SHOR DEVELOPMENT

SSD RESPONSE

1.0 Response to Government Architect's Office Commentary

DIAGRAM SHOWING SOUTH WEST FAÇADE ANGLING BACK FROM STREET, AND ADDITION OF SUNSHADING

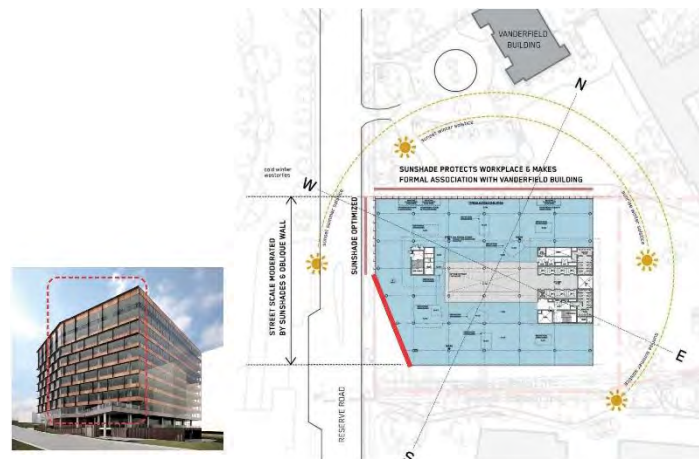
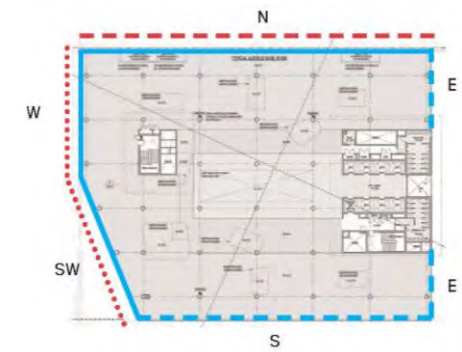
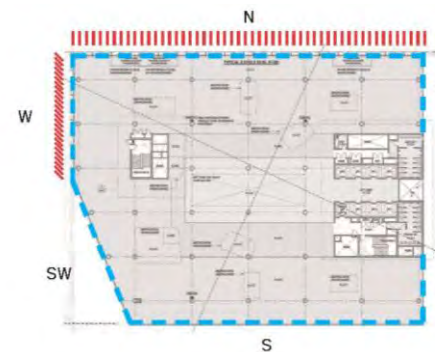
1.5. UNARTICULATED EXPANSES OF FAÇADE

- The extent of sunshade has been adjusted since submission (previously north and western façade) to extend across the south western façade also – acknowledging the high level of visibility this façade has on the southerly approach from Reserve Rd

SECTION THOROUGH NORTHERN COLONNADE

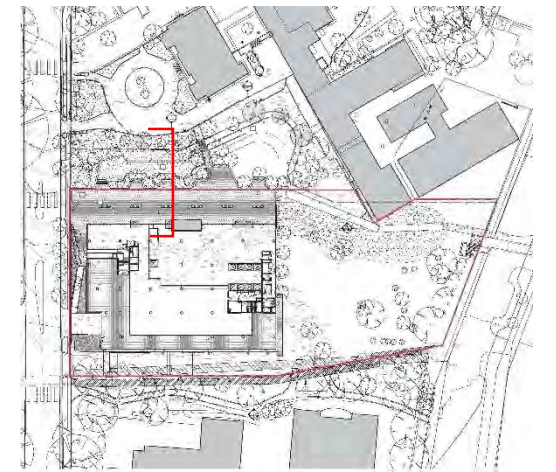
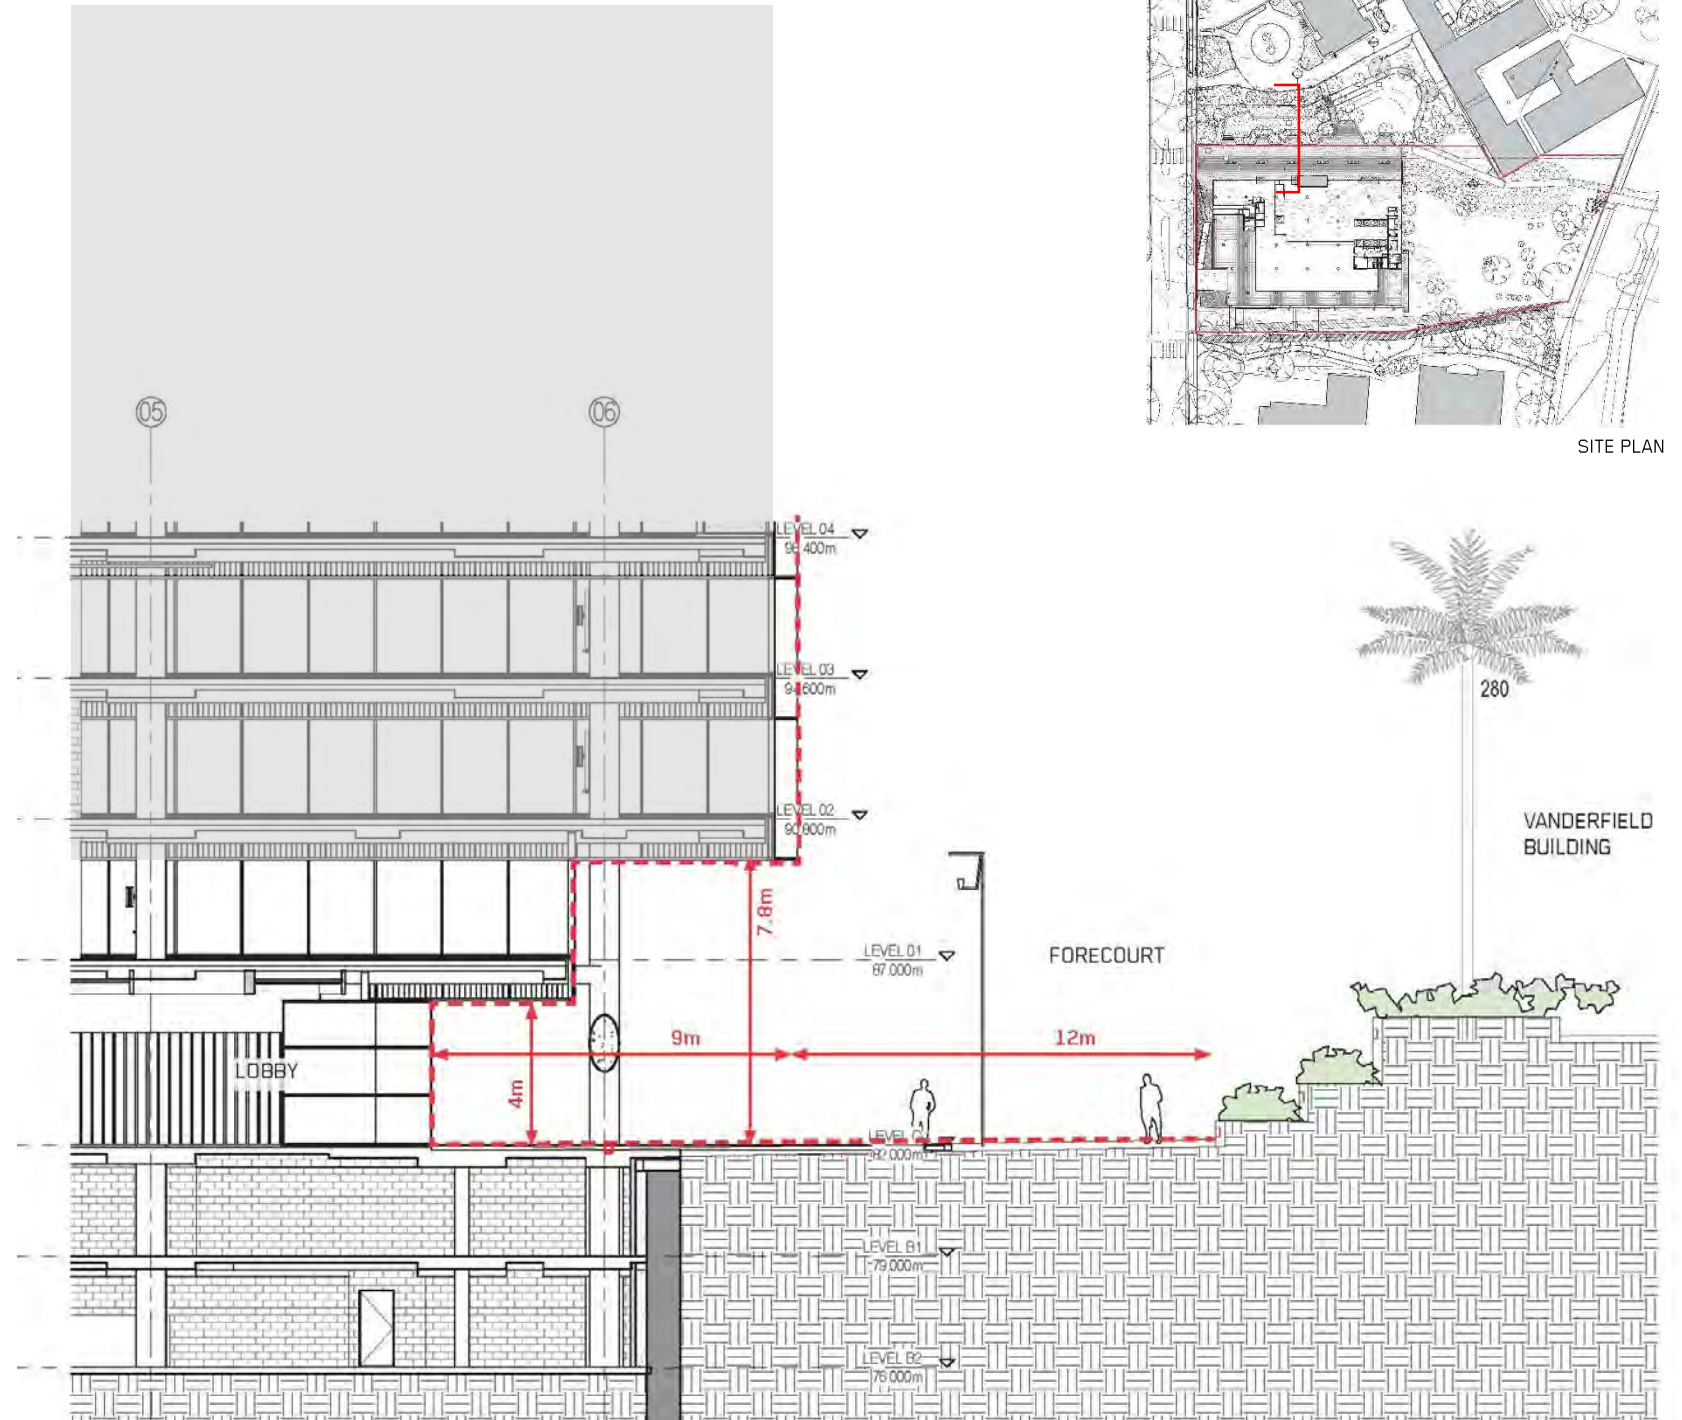
1.6. COLONNADED FRONTAGE

- The colonnaded frontage has been carefully considered to provide a sense of scale, shelter and activation:
 - The sculptural 'v' columns provide a dialogue to the arches of the Vanderfield
 - The colonnade provides shelter from the sun and the rain with a 2 storey high overhang stepping down to a single storey overhang as it transitions into the building's lobby.
 - The step down in scale of the colonnade responds to the differing qualities of the space – with the higher level responding to the northern garden court, and the single level responding to the building lobby and entrance
